Access Compliance Report

(Curb Ramps)

Intersection ID: 46027	Main Street: BOYSENBERRY_CT	Cross Street: PAULINE_LN	Location:	NW
ADA ID: A9F77803AE3C	Ramp Type: PerpDiag	Initial Pass/Fail: Fail	Overall Compliance: No	Severity Score: 25
Codes/Mitigation Info/Possible Solution		Field Measurements/Component Compliance

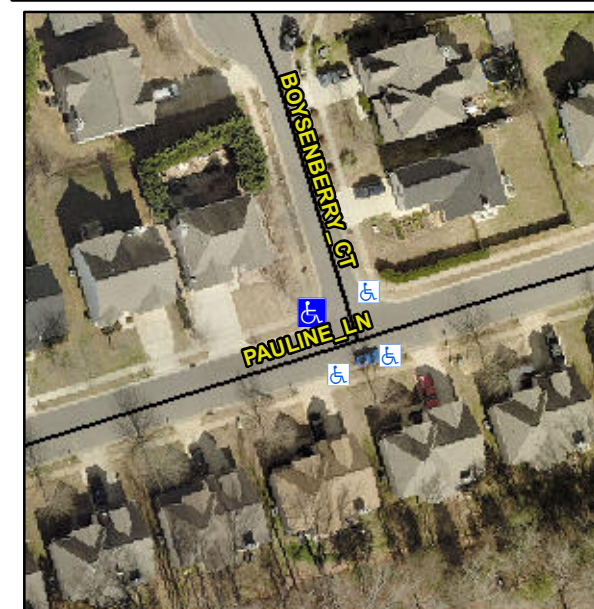
Not Found, R304.5.3

Compliance	Description	Data	Compliance	Description	Data
N/A	Ramp Length (in)	47.0	Yes	Ramp Slope (%)	6.3
Yes	Ramp Width (in)	48.0	No	Ramp XSlope (%)	7.2
N/A	Flare Type LT	N/A	N/A	Flare Type RT	N/A
N/A	Flare Slope LT (%)	N/A	N/A	Flare Slope RT (%)	N/A
N/A	Flare Traversable LT?	N/A	N/A	Flare Traversable RT?	N/A
N/A	Landing Length (in)	N/A	N/A	DWS Provided?	N/A
N/A	Landing Width (in)	N/A	N/A	DWS Contrast?	N/A
N/A	Landing Slope (%)	N/A	N/A	DWS Length (in)	N/A
N/A	Landing X Slope (%)	N/A	N/A	DWS Full Width?	N/A
N/A	Landing Curb? (Y/N)	N/A	N/A	DWS Offset (in)	N/A
N/A	Shared Landing?	N/A			
N/A	Gutter Ponding?	N/A	N/A	Gutter Slope (%)	N/A
N/A	Gutter Lip Ht (in)	N/A	N/A	Gutter X Slope (%)	N/A
N/A	Painted X Walk1?	No	N/A	Painted X Walk2?	No
	X Walk 1 Direction	To S		X Walk 2 Direction	To E
N/A	X Walk 1 Width (in)	N/A	N/A	X Walk 2 Width (in)	N/A
	X Walk 1 Slope (%)	4.5		X Walk 2 Slope (%)	3.8
	X Walk 1 X Slope (%)	4.1		X Walk 2 X Slope (%)	3.7

Remove & Replace Curb Ramp With Two New Directional Ramps or Equivalent.
